UN ECE Regulation No. 107
4th meeting of the GRSG Informal Group on
Service Doors, Windows and Emergency Exits of buses and coaches

Proposals to amend UN ECE Regulation No. 107 (M2 and M3 vehicles)

Figure 26

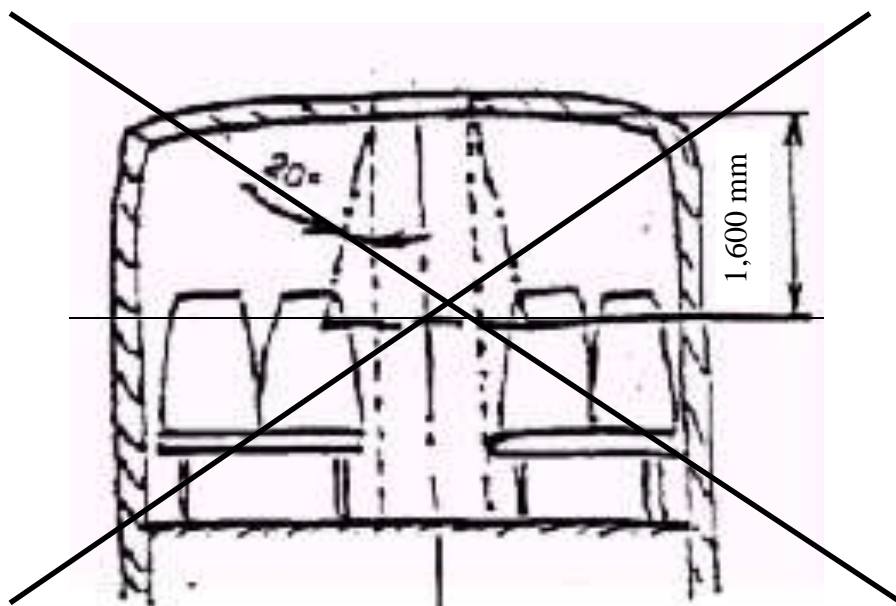
Delete paragraphs 7.7.4.1.1., 7.7.4.1.2. and their related figure 26

Reports on bus accidents have shown that the emergency hatches in the roof are only used when the bus or coach has tilted. While the bus or coach is in the driving position the emergency hatches are not used by the passengers in the case of emergency. Therefore it seems justifiable that no exit support is required.

(reserved)
